Site Name: Progress Energy Asheville Date: 29 MAY 2009
 Unit Name: 1964 POND Operator's Name: Progress ENERGY
 Unit I.D.: Hazard Potential Classification: High Significant Low

U. S. Environmental Protection Agency**Coal Combustion Waste (CCW)
Impoundment Inspection**

Impoundment Name PROGRESS ENERGY - ASHEVILLE 1964 PONDImpoundment Company PROGRESS ENERGYEPA Region IVState Agency (Field Office) Address N/AName of Impoundment 1964 POND

**ASHEVILLE STEAM ELECTRIC PLANT
COOLING LAKE DAM AND ASH POND DAMS
SKYLAND, NORTH CAROLINA**

Photograph 8: Cooling Lake Dam – spalling concrete on ogee spillway.

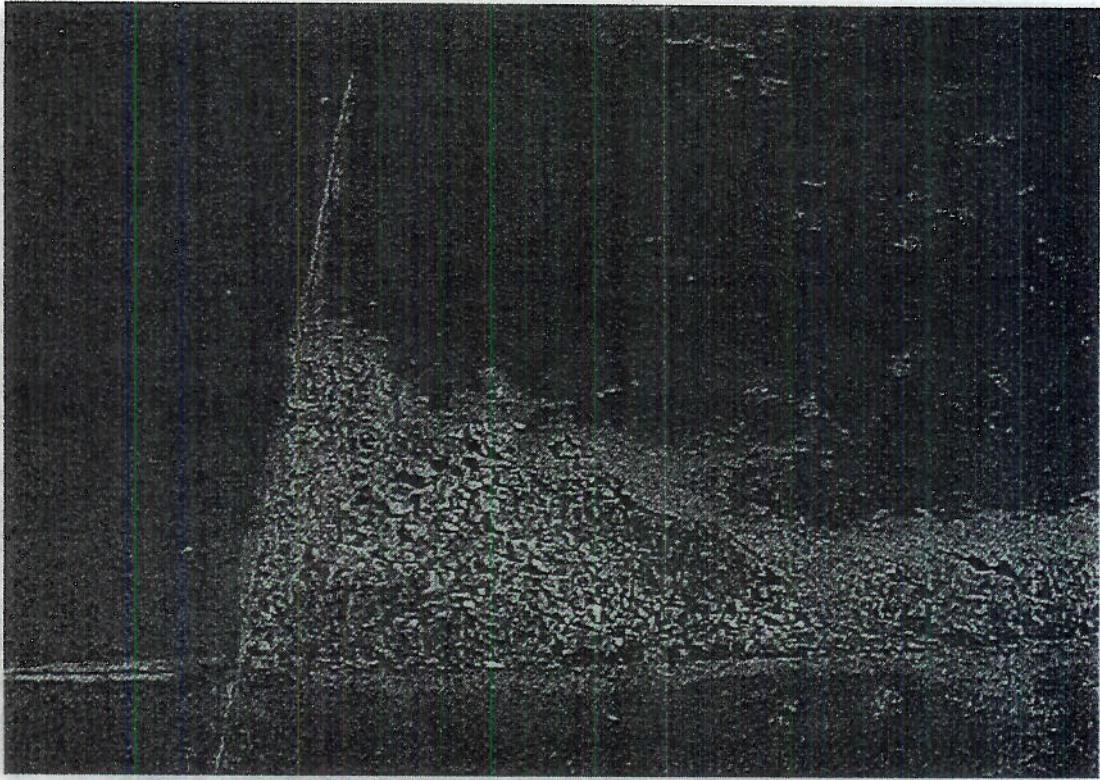
3. Repair the three areas of spalled concrete on the surface of the spillway slab.
4. Continue to remove accumulated sediment from behind the weir, as required.
